# User Stories for IEC/IEEE 60802

# system definition

Contributors: Guenter Steindl Marius-Petru Stanica Martin Ostertag Rene Hummen Stephan Kehrer Mark Hantel

Figure 4: Simple TSN Domain – remove a device

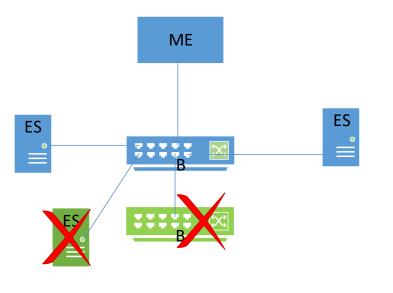
**Commented [RB24]:** Soft or hard removal. below I agree with Marius about considering a state machine for the ME.

**Commented [MS26]:** In general, such activities happen either as a result of a maintenance activity, either as a human error, either as a device or entire process area failure. Now, I am wondering whether we should introduce a simple state machine for the ME. This would help, for example, avoiding unneeded alarms and events, in case of a maintenance.

**Commented [MH27]:** Add a user story for device disappearing? How to differentiate between a device being removed for maintenance (and is expected to return), a device that fails (and the failure is expected to assert an alarm), and a device that is removed by a user as a planned event?

**Commented [MH25R24]:** I believe the intention is either. Added this to the text

Figure 5: Simple TSN Domain – combine previously splitted TSN Domain

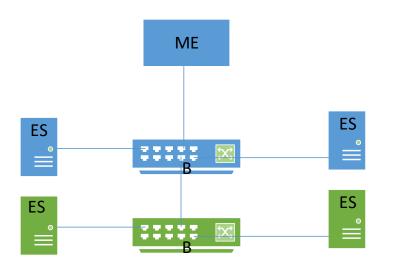
**Commented [MS30]:** This is a complex situation, which would need further analysis of a ME state machine. In my opinion, in order to be able to safely perform such an use case, both ME state machines must be in "compatible" states, in order to allow the joining of their domains. Only after this, a mechanism of election of the new ME can be activated. Such an election mechanism should be also detailed, in my view, there are also some options: either only one ME is chosen, either one ME becomes the redundant of the other one, thus a sort of configuration mirroring process between the two could be activated.

Furthermore, the newly elected overall ME (covering both TSN domains) must get information about the existing devices and streams of the newly connected TSN domain. Following options seem present:

- if the newly added TSN domain is simply a collection of TSN devices without any ME, then the devices must be discovered by the only existing ME (the one belonging to the initial TSN domain). So, use case 2.1 is repeated for each device of the new TSN domain.
- if the newly added TSN domain has a ME, then once the election process is done, a data exchange must be put into place between the two MEs so that the newly elected overall ME has the information about the devices in the newly added TSN domain

Figure 6: Simple TSN Domain –split TSN Domain

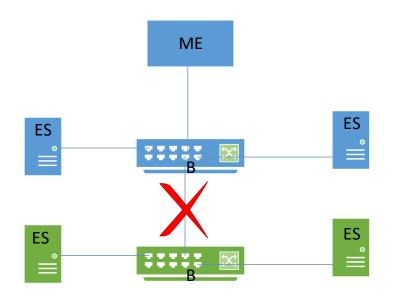
**Commented [MS31]:** Yet another use case requiring the existence of a ME state machine, which can allow a functioning mode for the TSN domain specific to maintenance, so that the process is as little as possible influenced. Anyway, a similar discussion as in the previous comment should be done with regards to the presence or not, after the split, of a ME per each of the newly created TSN domains.

**Commented [MS32]:** Perhaps in a first phase. This depends on how we assign TSN domain identifiers, once the TSN domain is split and the ME state machines of each TSN domain (if present in both) out of maintenance state, a new TSN domain identifier may be assigned to any of the newly created TSN domains.

# Figure 11: Principles

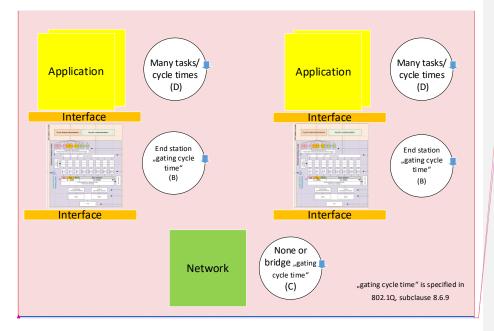
**Commented [MS50]:** Is it "end station interface" meant in the drawing or network interface of the end station?

Figure 15: Clock usage model

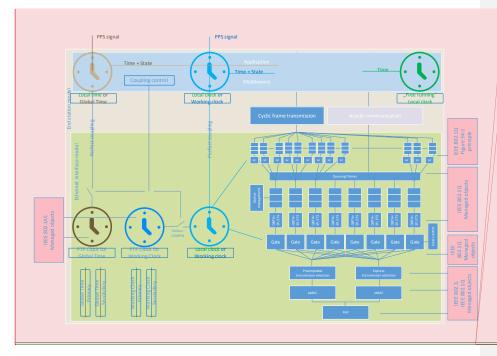
**Commented [MS52]:** I would like to propose an update of this drawing, as this drawing raised many comments also in D1.2. It is useful, in my view, for the reader, to associate the clocks governing the timely behavior to their relevant sections in an end station.

**Commented [MS53R52]:** I would still like to add the proposal I have done for this drawing, in Figure 14a(next page). The proposal currently shown in Figure 14 seems to be only one way of using the clocks. Personally, I find it very complex, due to the mixing of the PTP clock at the application level. Perhaps needed in some situations, but in my view, definitely not needed for all end stations which will be TSN enabled (thus it could be optional).
